Access Compliance Report

Public Rights-of-Way

(Curb Ramps)

Intersection ID: 26940	Main Street: ESHERWOOD_LN	Cross Street: WYNYATES_LN	Location: W
ADA ID: 0A620AA24016	Ramp Type: Perp	Initial Pass/Fail: Fail	Overall Compliance: No
		Severity Score: 12.5

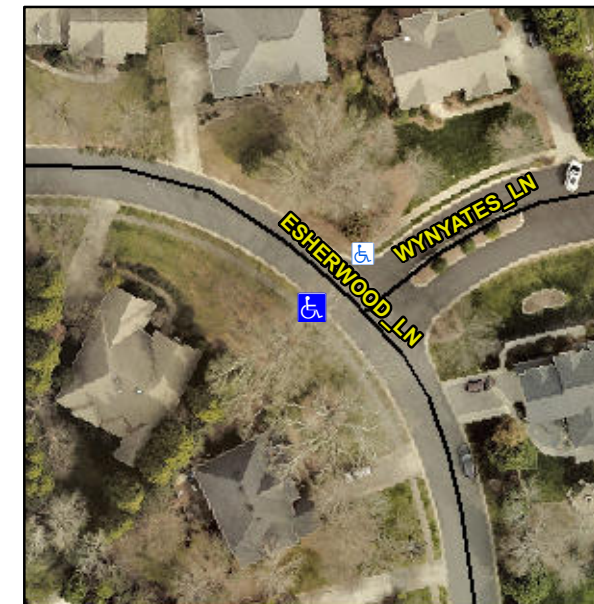
Not Found, R304.2.2

Compliance	Description	Data	Compliance	Description	Data
N/A	Ramp Length (in)	47.5	No	Ramp Slope (%)	9.2
Yes	Ramp Width (in)	48.0	Yes	Ramp XSlope (%)	0.8
N/A	Flare Type LT	N/A	N/A	Flare Type RT	N/A
N/A	Flare Slope LT (%)	N/A	N/A	Flare Slope RT (%)	N/A
N/A	Flare Traversable LT?	N/A	N/A	Flare Traversable RT?	N/A
N/A	Landing Length (in)	N/A	N/A	DWS Provided?	N/A
N/A	Landing Width (in)	N/A	N/A	DWS Contrast?	N/A
N/A	Landing Slope (%)	N/A	N/A	DWS Length (in)	N/A
N/A	Landing X Slope (%)	N/A	N/A	DWS Full Width?	N/A
N/A	Landing Curb? (Y/N)	N/A	N/A	DWS Offset (in)	N/A
N/A	Shared Landing?	N/A			
N/A	Gutter Ponding?	N/A	N/A	Gutter Slope (%)	N/A
N/A	Gutter Lip Ht (in)	N/A	N/A	Gutter X Slope (%)	N/A
N/A	Painted X Walk1?	No	N/A	Painted X Walk2?	N/A
	X Walk 1 Direction	To NE		X Walk 2 Direction	N/A
N/A	X Walk 1 Width (in)	N/A	N/A	X Walk 2 Width (in)	N/A
	X Walk 1 Slope (%)	1.5		X Walk 2 Slope (%)	N/A
	X Walk 1 X Slope (%)	0.6		X Walk 2 X Slope (%)	N/A

Remove & Replace Entire Ramp.
